PORT BOTANY EXPANSION

SHIP TURNING AREA DREDGING

SECTION 96 (1A) MODIFICATION

May 2009

Figure 1: Approved Dredging and Reclamation (From URS, 2003)

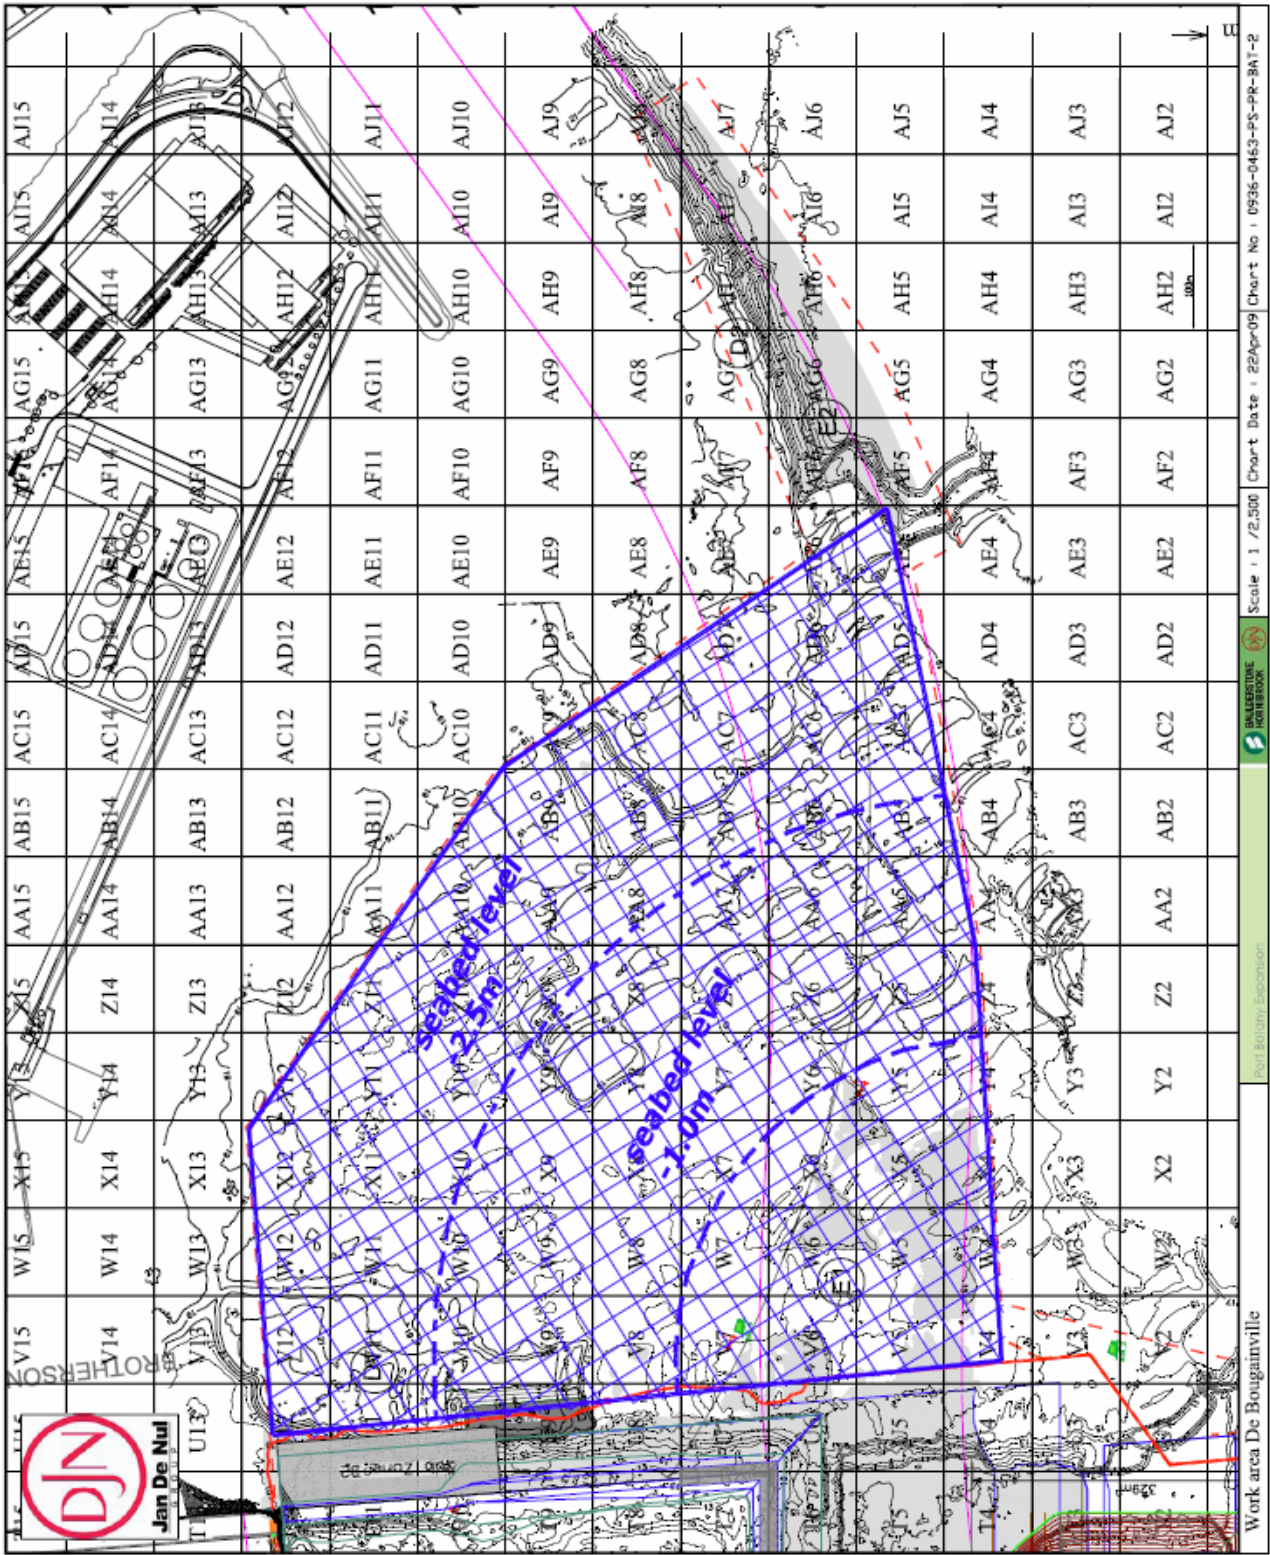
Figure 8.4 of the EIS, reproduced below as Figure 1, identifies the approved dredging configuration.

The proposed dredging would not change the principal dredging and reclamation activities described in the EIS. In particular, there would be no change to the dredging of 220,000m³ of sand to remove high spots outside the primary silt curtain.

ATTACHMENT 'A'

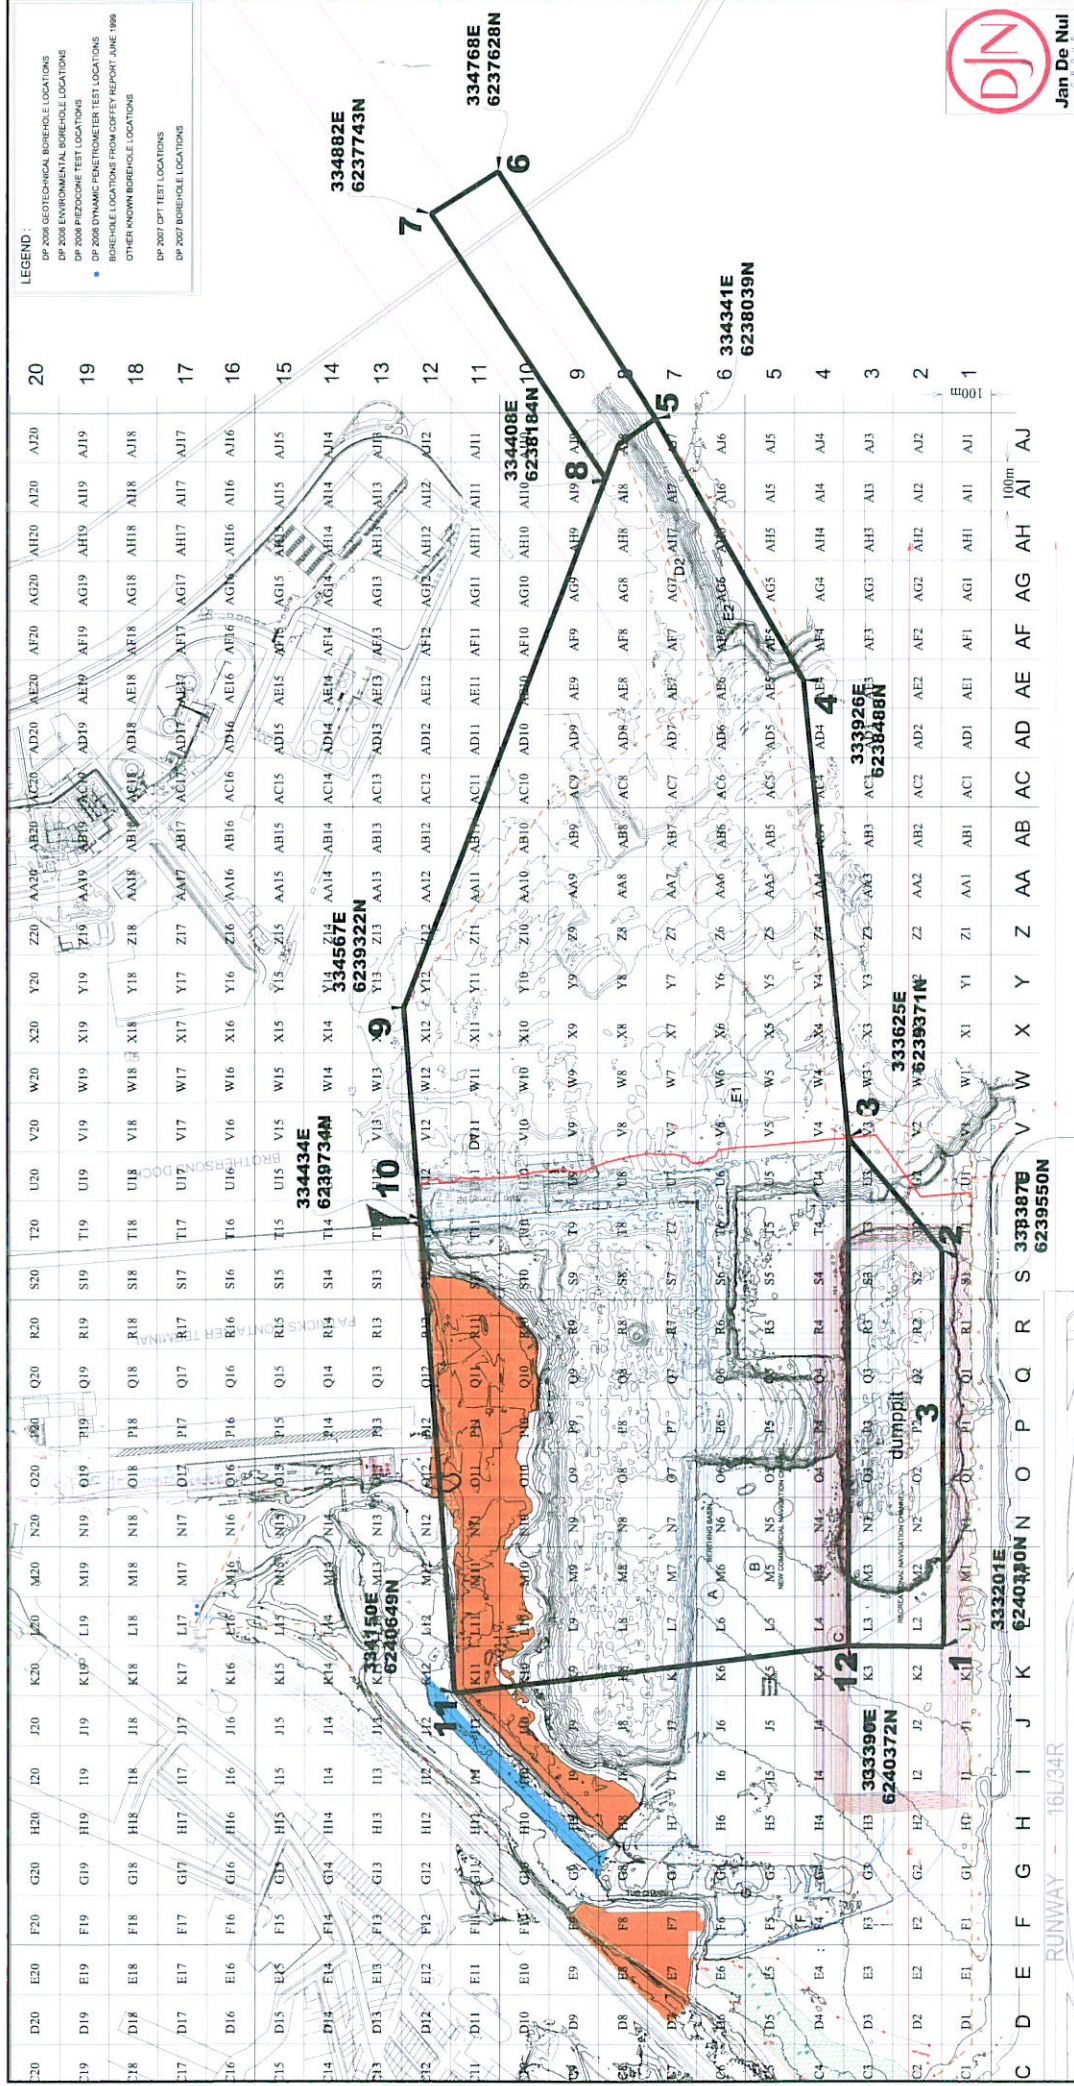
- the maximum height of the dredge is not to exceed a height of 24.0 metres above Australian Height Datum (AHD).
- the dredge may be operated within the area bounded by Positions 3 to 12 only (as indicated on Attachment "A"),
